Access Compliance Report

Public Rights-of-Way

Intersection ID: 9962	Main Street: LITTLE ROCK RD	Cross Street: TUCKASEEGEE RD	Location: S
ADA ID: 8BE4F6FC1C65	Ramp Type: Perp	Initial Pass/Fail: Fail	Overall Compliance: No
Severity Score: 22.5			
Codes/Mitigation Info/Possible Solution		Field Measurements/Component Compliance

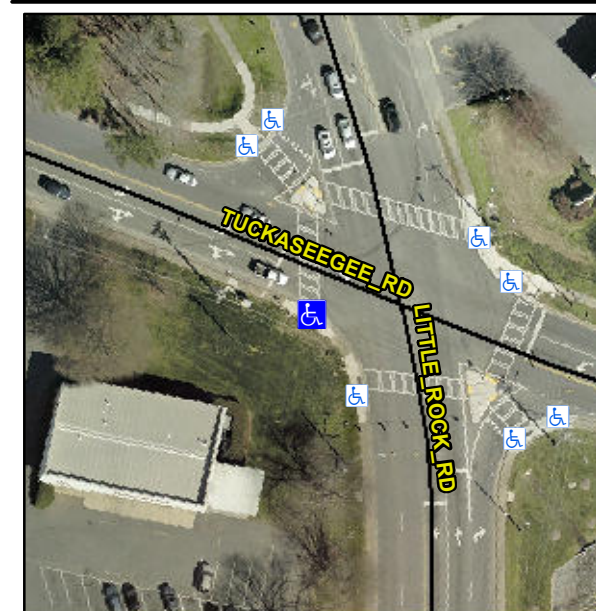
R304.5.1, R304.2.2

Compliance	Description	Data	Compliance	Description	Data
N/A	Ramp Length (in)	49.0	No	Ramp Slope (%)	10.5
No	Ramp Width (in)	36.0	Yes	Ramp XSlope (%)	2.8
N/A	Flare Type LT	N/A	N/A	Flare Type RT	N/A
N/A	Flare Slope LT (%)	N/A	N/A	Flare Slope RT (%)	N/A
N/A	Flare Traversable LT?	N/A	N/A	Flare Traversable RT?	N/A
N/A	Landing Length (in)	N/A	N/A	DWS Provided?	N/A
N/A	Landing Width (in)	N/A	N/A	DWS Contrast?	N/A
N/A	Landing Slope (%)	N/A	N/A	DWS Length (in)	N/A
N/A	Landing X Slope (%)	N/A	N/A	DWS Full Width?	N/A
N/A	Landing Curb? (Y/N)	N/A	N/A	DWS Offset (in)	N/A
N/A	Shared Landing?	N/A			
N/A	Gutter Ponding?	N/A	N/A	Gutter Slope (%)	N/A
N/A	Gutter Lip Ht (in)	N/A	N/A	Gutter X Slope (%)	N/A
N/A	Painted X Walk1?	No	N/A	Painted X Walk2?	N/A
	X Walk 1 Direction	To NW		X Walk 2 Direction	N/A
N/A	X Walk 1 Width (in)	N/A	N/A	X Walk 2 Width (in)	N/A
	X Walk 1 Slope (%)	2.3		X Walk 2 Slope (%)	N/A
	X Walk 1 X Slope (%)	2.9		X Walk 2 X Slope (%)	N/A

Remove & Replace Entire Ramp.
